07/06/22 - Canal & River Trust requirements relating to navigational safety for proposed footbridge crossings over the Oxford Canal in the Jericho area of Oxford.

Proposed Bridges and Trust comments

Approximate locations of proposed bridges

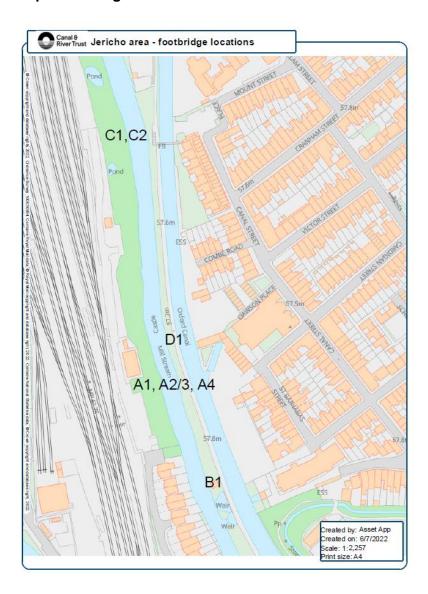
Trust comments – acceptable on navigational safety grounds, assuming no changes to the existing span over the navigation other than the addition of accessible ramps

Trust comments – acceptable on navigational safety grounds, assuming no changes to the existing span over the navigation of the existing bridge at C1 other than the addition of accessible ramps, although the Trust would not permit this design due to the adverse impact on its existing commercial agreements

Trust comments - not acceptable on navigational safety grounds.

Trust comments— may not be acceptable on navigational safety grounds – would need further investigation as the Trust has not received a detailed proposal for a bridge at this location.

D1 – New fixed bridge spanning canal and towpath, located at southern end of proposed boatyard building

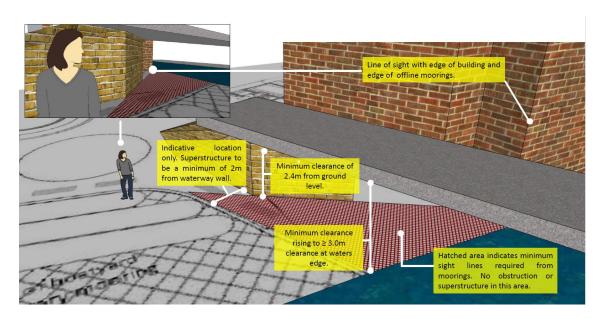
Trust comments – acceptable on navigational safety grounds, subject to the following constraints...

Navigation constraints – minimum of 3.0m clearance above normal water level across the full width of the canal.

Towpath side constraints – bridge abutments to be positioned to the rear of the towpath, minimum headroom to be 2.7m over full width of towpath from water's edge to face of abutment. No building out into the existing channel.
